**1958 Agreement – Consideration of draft amendments
to existing Regulations submitted by GRSP**

Proposal for 03 series of amendments to Regulation No. 94 (Frontal collision)

Submitted by the Working Party on Passive Safety *

Model B

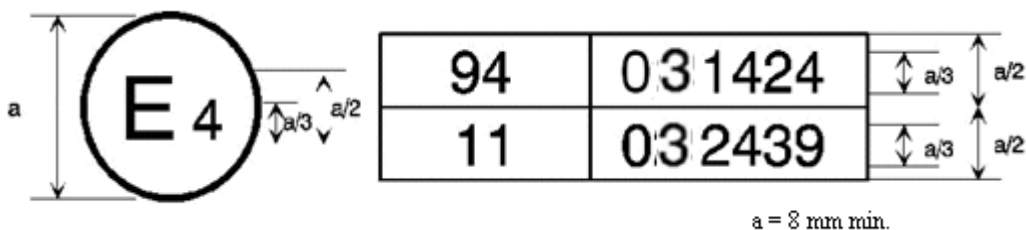
Annex 2, amend to read:

The first two digits of the approval numbers indicate that, at the dates when the respective approvals were granted, Regulation No. 94 incorporated the 03 series of amendments and Regulation No. 11 incorporated the 03 series of amendments."
